ADDENDUM NUMBER 2

MILWAUKEE COUNTY TRANSIT SYSTEM
FOND DU LAC MAINTENANCE BUILDING
ROOF REPLACEMENT
Site #210, Bldg. #102
3203 W. Fond Du Lac Avenue
Milwaukee, WI

Project Number: T044-10463

Date of Addendum: November 19, 2010

A2.2

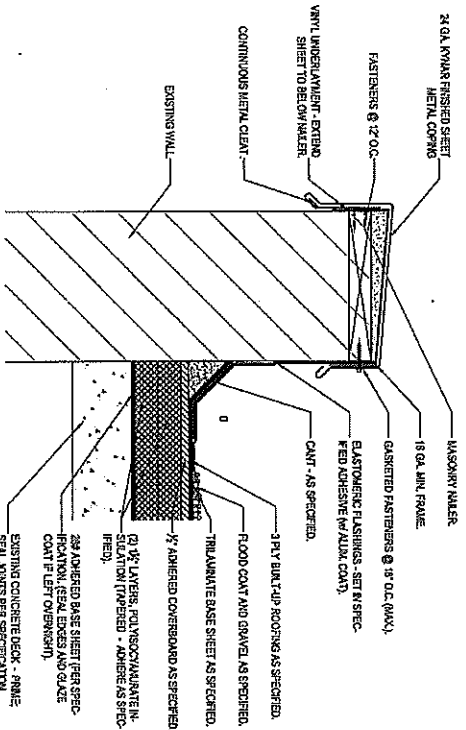
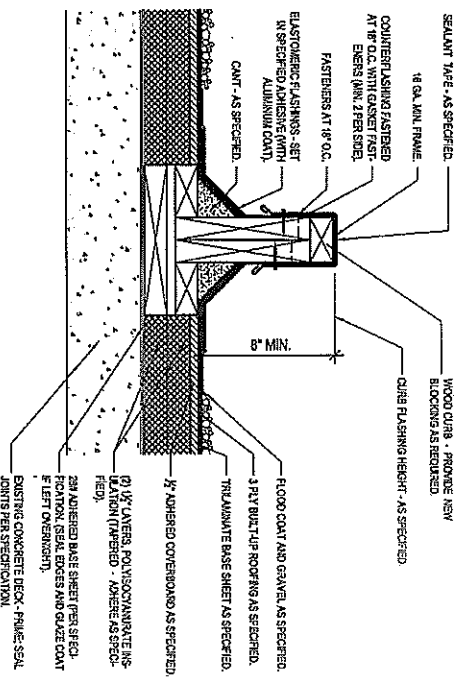
5. An additional sheet of drawn details is included in the bid set (See attached drawn details; sheet A2.2 issued as part of Addendum #2, Drawing Attachment #1).

#3 HVAC CURB / SLIP METAL COUNTER FLASHING DETAIL
 SCALE: NTS

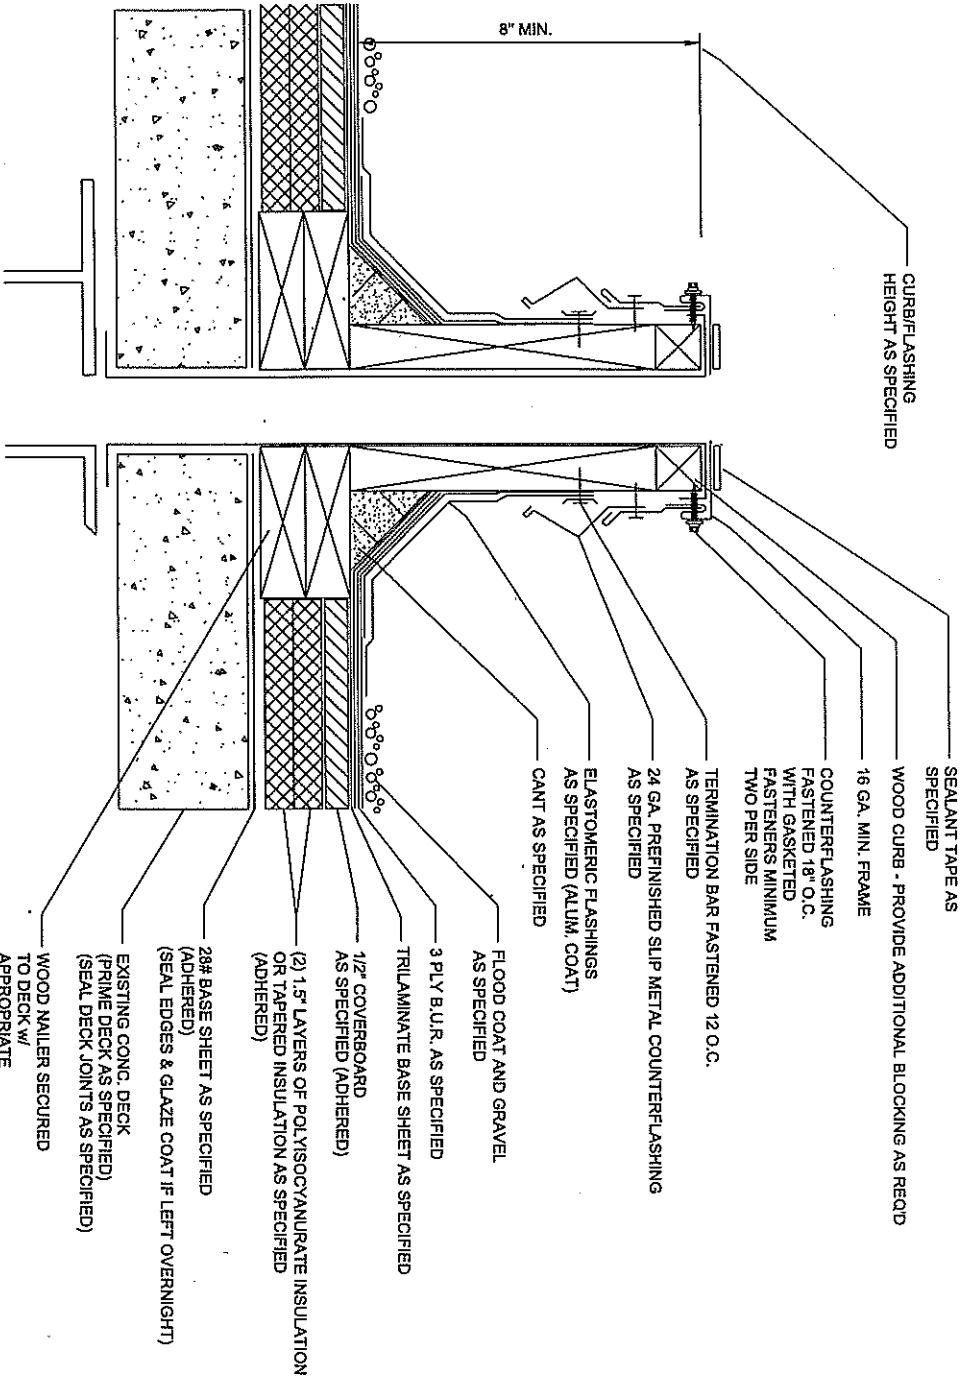
7. Roofing contractor shall use a slip metal counterflashing detail at rooftop unit flashings (See attached revised drawing; detail #3 issued as part of Addendum #2, Drawing Attachment #2).
